STATE OF MAINE
 DEPARTMENT OF TRANSPORTATION
 16 STATE HOUSE STATION
 AUGUSTA, MAINE
 04333-0016

May 3, 2010
 Subject: **Scarborough, Falmouth,
 Cumberland, Yarmouth, Freeport,
 South Portland & Portland**
Federal Project No: IM-1678(700)E,
 IM-1705(510)E, HPP-1705(520)E,
 HP-1563(400)E & IM-1779(300)E
State Pin No: 016787.00, 017055.10,
 017055.20, 015634.00 & 017793.00
Amendment No. 1

In the Plans for Portland (HP-1563(400)E – I-295 Exit 7 (Franklin Street)), **REMOVE** Sheet Numbers 10 of 76 (Traffic Signal Plan) and 11 of 76 (Traffic Signal Plan) and **REPLACE** with the attached new Sheet Numbers 10 of 76 (Traffic Signal Plan) and 11 of 76 (Traffic Signal Plan).

In the Plans, **ADD** the attached “APPENDIX A” for IM-1779(300)E , 11 plan sheets total.

INTERSTATE 295 SOUTHBOUND
FALMOUTH TO S. PORTLAND
CUMBERLAND COUNTY
ESTIMATED BRIDGE QUANTITIES

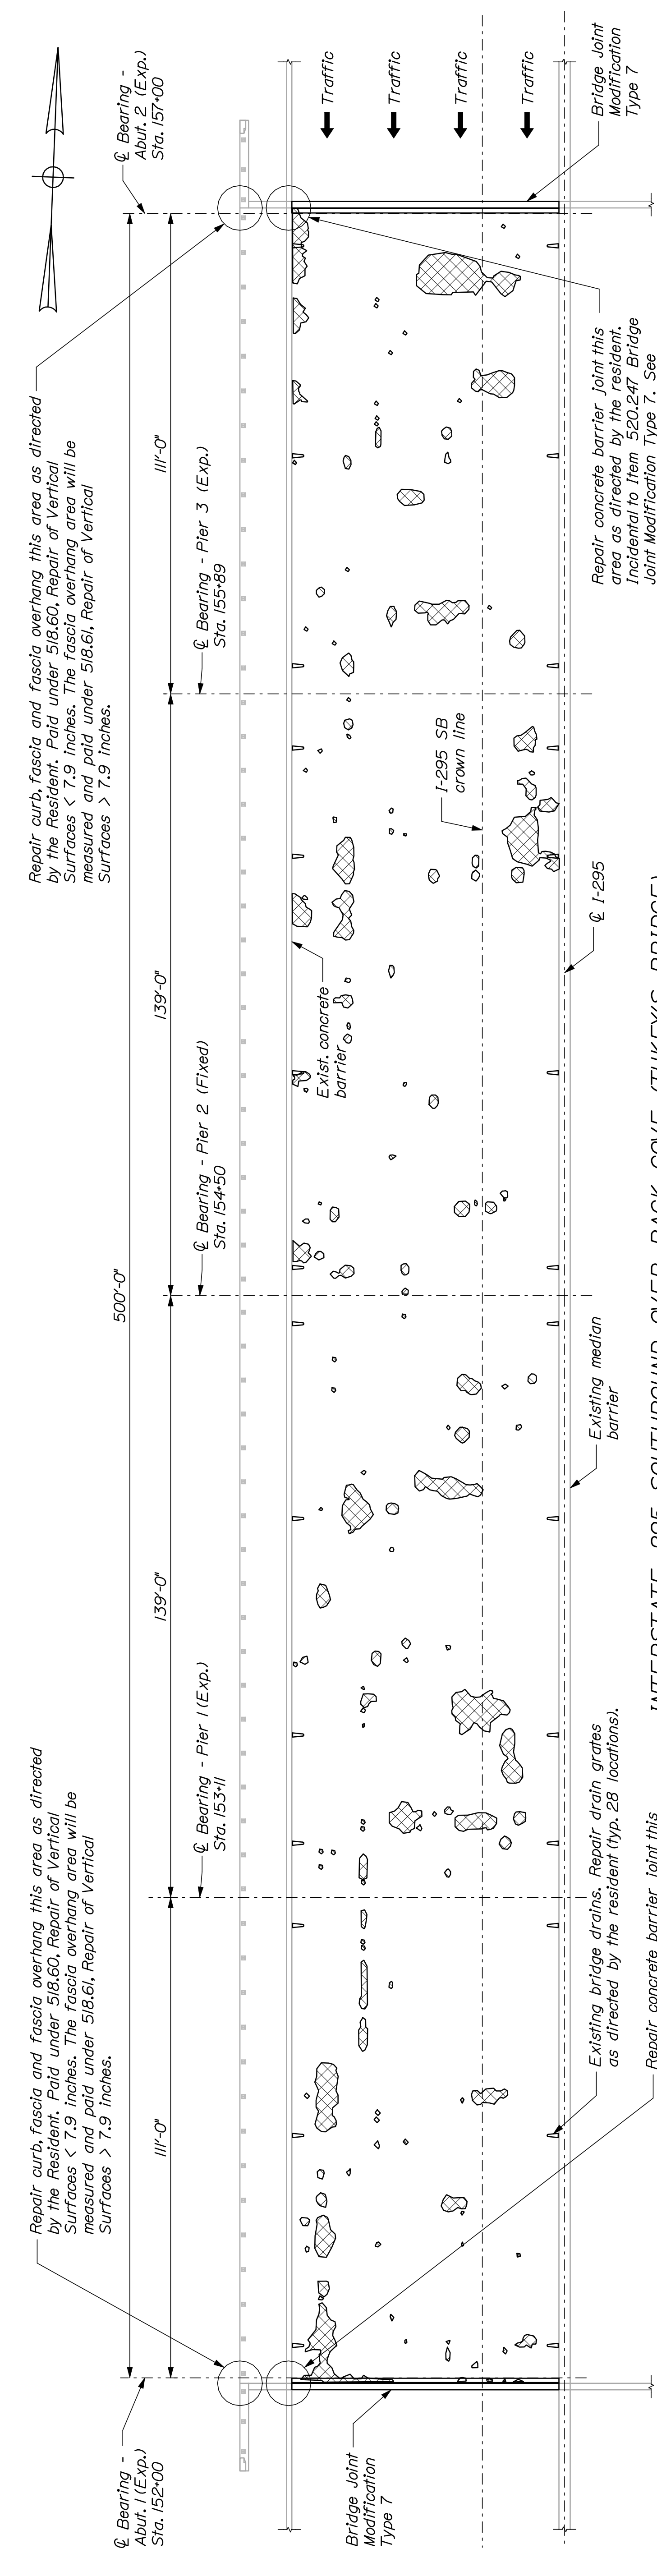
Question: The Estimated Quantities in the bridge pin IM-1779 do not match with the bridge quantities listed in the bid items. Please clarify.
Appendix A from pin IM-1779 seems to be missing; this appendix includes information on Preble and Tukey's bridges.

Response: The total quantities in the bid book are the totals including the Tukey's and Preble Street bridges. The total on the first sheet of the plans do not include the quantities for those bridges. The appendix (attached) has the additional quantities for those bridges.
